SUBDIVISION & ZONING AMENDMENT STAFF REPORT Date: August 6, 2020

APPLICANT NAME QuikTrip Corporation

SUBDIVISION NAME Highway 90 – Interstate 10 Business Park Subdivision

CONTEMPLATED USE Subdivision Approval to create a two legal lots of record from one legal lot of record and one metes-and-bounds parcel; and Rezoning from B-3, Community Business District and B-5, Office-Distribution District to B-3, Community Business District.
It should be noted, however, that any use permitted in the proposed district would be allowed at this location if the zoning is changed. Furthermore, the Planning Commission may consider zoning classifications other than that sought by the applicant for this property.

SITE PLAN

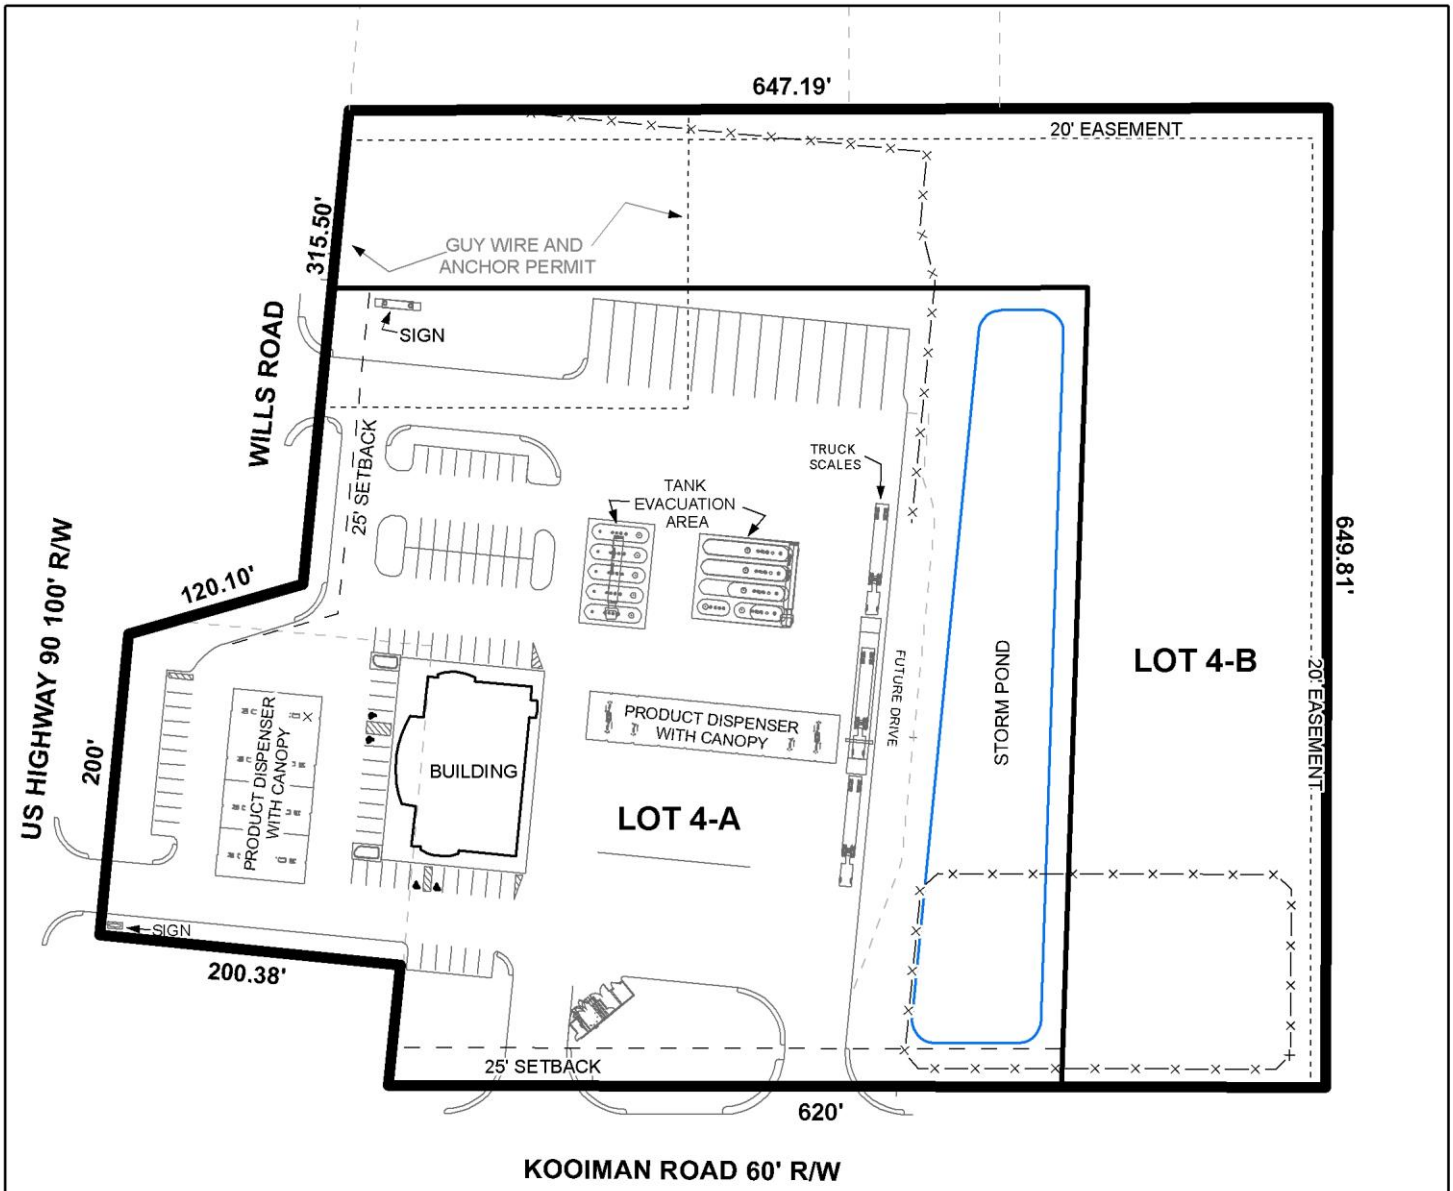
The preliminary plat illustrates the 25' minimum building setback lines along the frontages for the portion of the site that is an existing legal lot, but not along the frontage of the existing metes-and-bounds parcel. If approved, the plat should be revised to depict the 25' minimum building setback lines along the entirety of both frontages, adjusted for any dedication that may be required along that portion of the site that is currently a metes-and-bounds parcel along U.S. Highway 90 West.

The site plan submitted for the proposed development on Lot 4-A depicts two proposed curb cuts to Kooiman Road, and two proposed curb cuts to U.S. Highway 90 West / Linwood Steiner Road. Per Traffic Engineering this is acceptable for Lot 4-A. The proposed Lot 4-B is limited to one curb cut per street frontage. If approved, a note stating Traffic Engineering comments should be placed on the Final Plat.

2) retention of the lot sizes in square feet and acres;
3) revision of the plat to depict the 25' minimum building setback lines along the entire frontage of each lot;
